Date	19/05/2016
Number	0682
Pages	8

### TECHNICAL INFORMATION

MODEL	MT09 / MT09A / FZ09 / MT09TRA / FJ09
SUBJECT	CAM CHAIN TENSIONER (CCT) NOISE

## **FACTORY SOLUTION:**

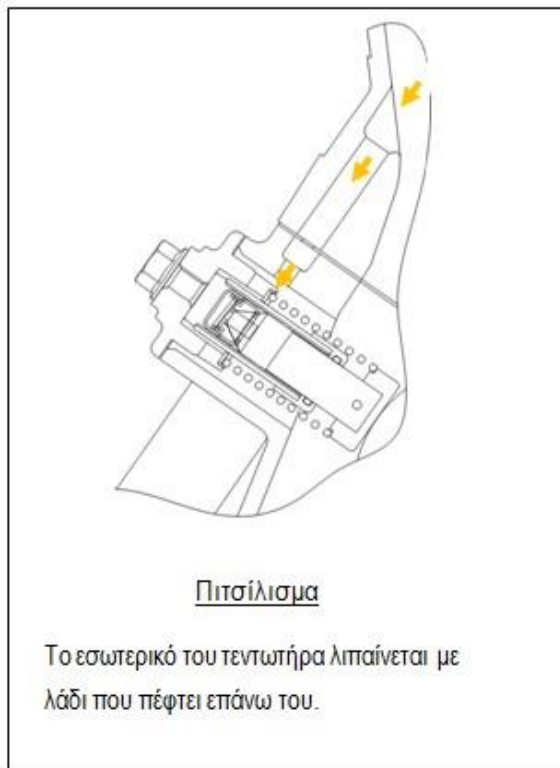
The way lubrication changed from splashing in pressure lubrication.

## **PART NUMBER INFORMATION**

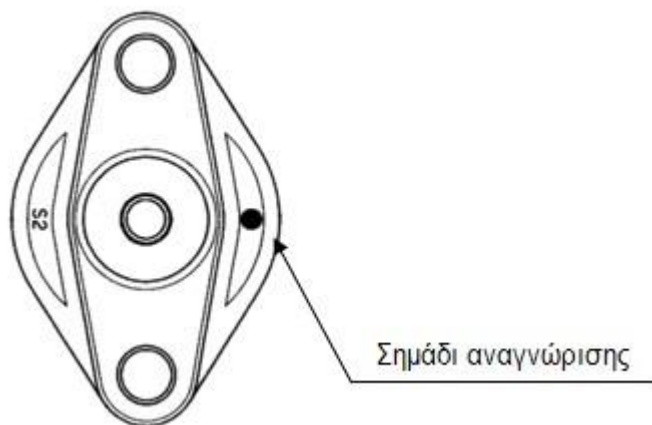
DESCRIPTION	OLD CODE	NEW CODE	QTY
TENSIONER	1RC-12210-04	B90-12210-00	1

Old cam chain tensioner (CCT) cannot be replaced from the new one.

The color identification sign has changed

### SOLUTION FOR VEHICLES ALREADY ON THE ROAD:

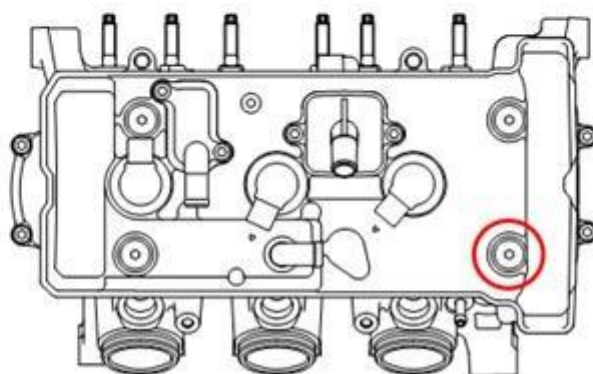
The existing oil flow is changed in a way that improves the lubrication of the tensioner.

One of the head cap screws is replaced with a bearing inner oil passage to convey oil from the easel camshaft on the roller.

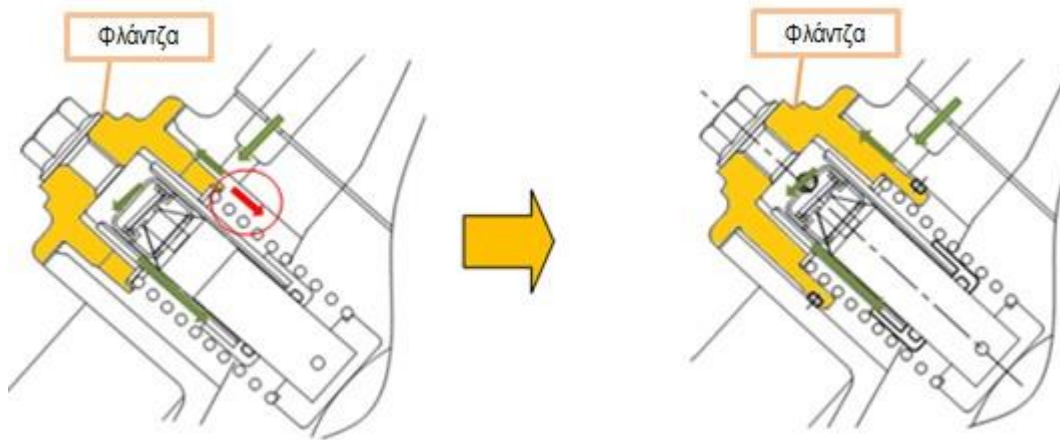
To effectively lubricated inside the tensioner, the inner flange of the tensioner grew to drive more oil in disputed wear point of the tensioner.

In case of a problem, replace the tensioner and place all the parts of improved kit.

End gap

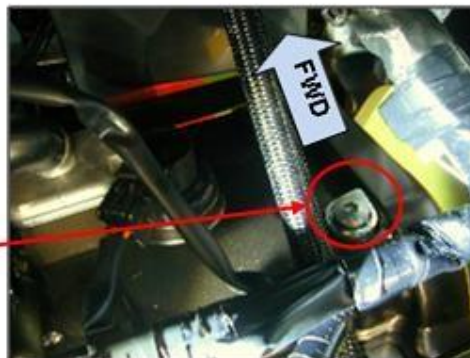
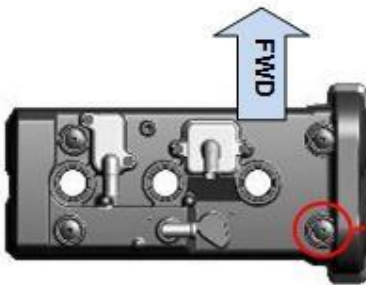
Τοποθετήστε τον τεντωτήρα με το άνοιγμα του δαχτυλιδιού προς την κάτω πλευρά του κινητήρα.

Ίσως δυσκολευτείτε στην τοποθέτηση του τεντωτήρα λόγω ανοχών ανά περίπτωση. Σε αυτήν την περίπτωση σφίξτε από λίγο και εναλλάξ κάθε μία από τις βίδες του τεντωτήρα μέχρι αυτός να πατήσει στον στροφαλοθάλαμο.

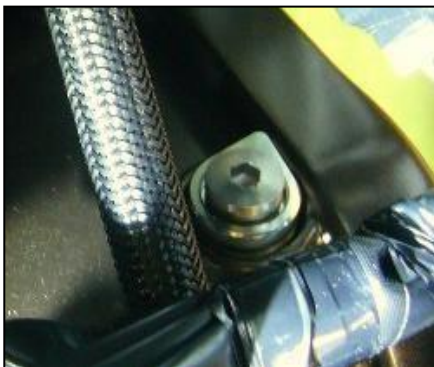
Replace the right screw cap shown in figure with the screw, the flange and the housing provided in the kit. Tighten to 10Nm.

Before tightening the screw, align the casing with the cover, as shown in figure.

**ΣΗΜΕΙΩΣΗ :** Δώστε προσοχή στην τοποθέτηση της θήκης. Εάν δεν ευθυγραμμιστεί σωστά δεν θα περάσει λάδι προς τον τεντωτήρα.

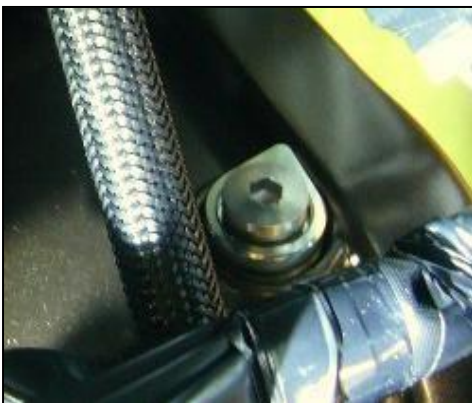
As in the process for kit 1, replace the right screw cap shown in figure with the screw, the flange and the housing provided in the kit. Tighten to 10Nm.

Before tightening the screw, align the casing with the cover, as shown in figure.

**ΣΗΜΕΙΩΣΗ :** Δώστε προσοχή στην τοποθέτηση της θήκης. Εάν δεν ευθυγραμμιστεί σωστά δεν θα περάσει λάδι προς τον τεντωτήρα
